**RFB NO. 315047 - ADDENDUM NO. 1**

**HENRY VILAS ZOO – PLAYGROUND RESURFACING**

**SITE PLAN & UTILITIES**

FILE NO.  
**12698003**  
SHEET  
**ST 2**

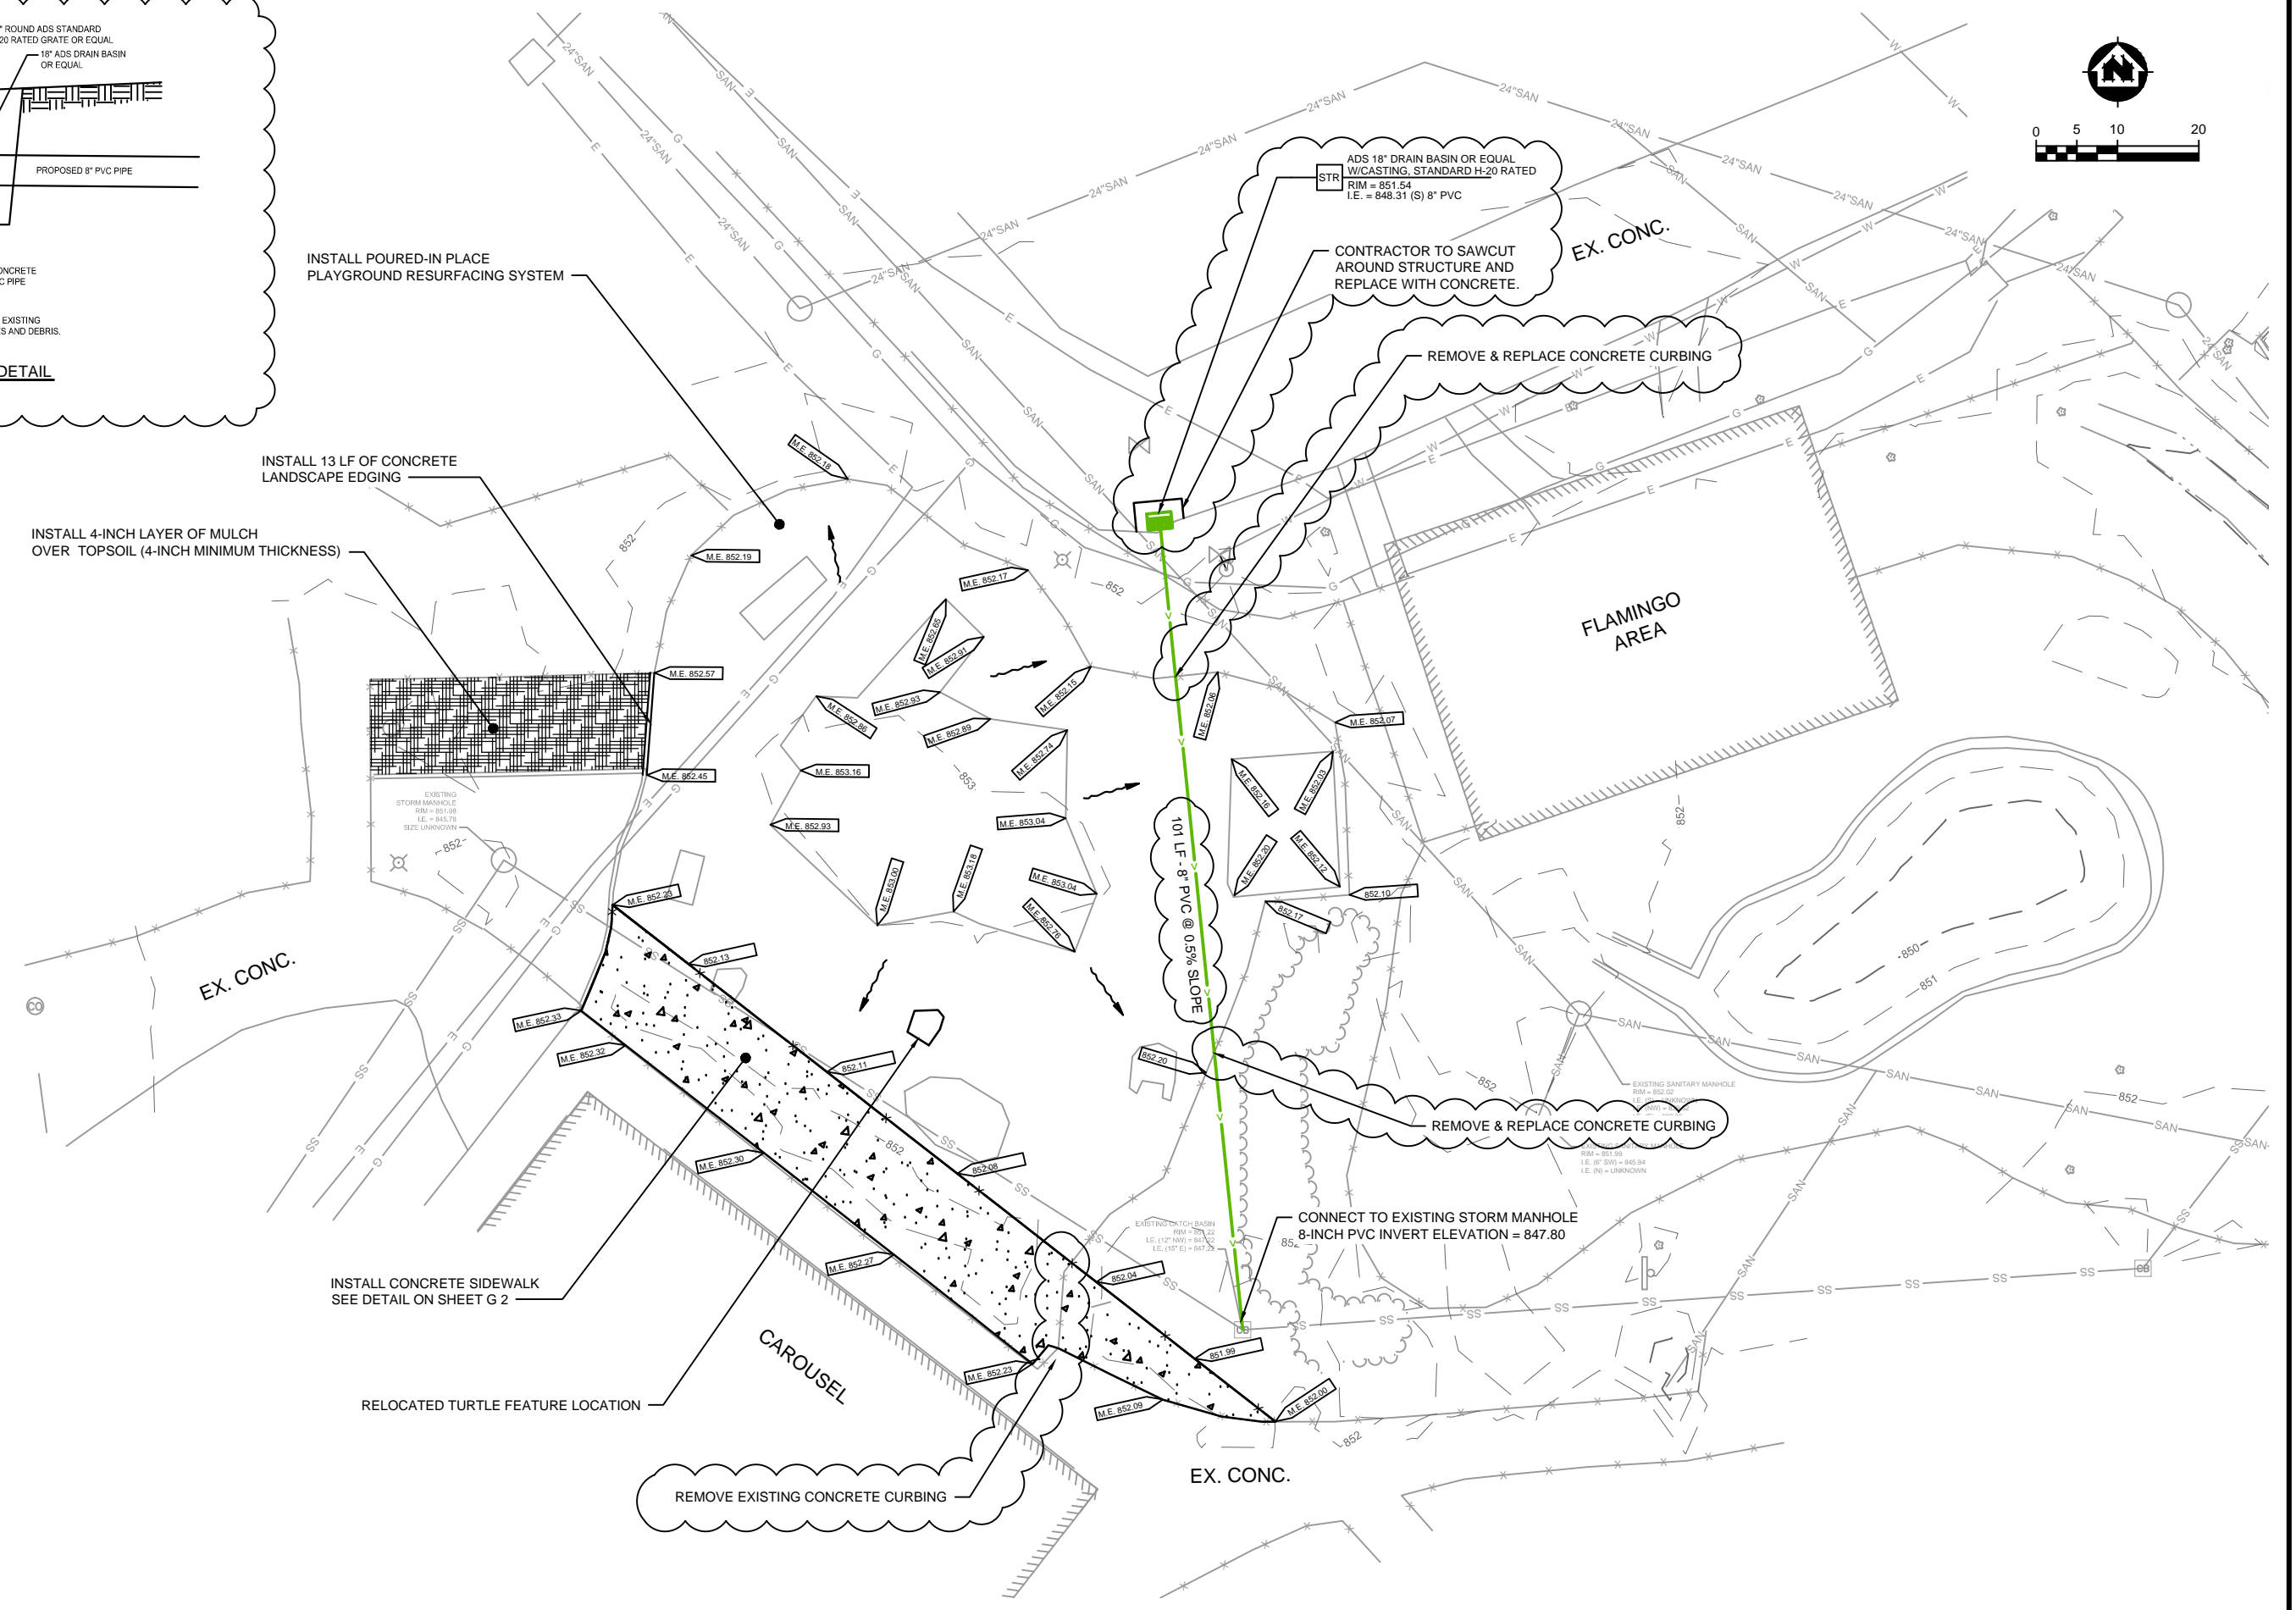
**2. Sheet ST 2 - Modify**

Modify current Sheet ST 2 as shown on Drawing ST 2, issued with this Addendum.

Storm structure location and type has changed extending the pipe length. Pavement area to be sawcut and concrete added around the storm structure casting following installation. Additional areas of concrete landscaping edging to be removed and replaced are noted.

CONTRACTOR SHALL PROVIDE CONCRETE BELOW THE INVERT OF THE 8" PVC PIPE TO REMOVE THE SUMP.  
BACKFILL EXCAVATED HOLE WITH EXISTING MATERIAL, FREE OF LARGESTONES AND DEBRIS.

INSTALL 13 LF OF CONCRETE LANDSCAPE EDGING

CONTRACTOR TO SAWCUT AROUND STRUCTURE AND REPLACE WITH CONCRETE.

CONNECT TO EXISTING STORM MANHOLE 8-INCH PVC INVERT ELEVATION = 847.80
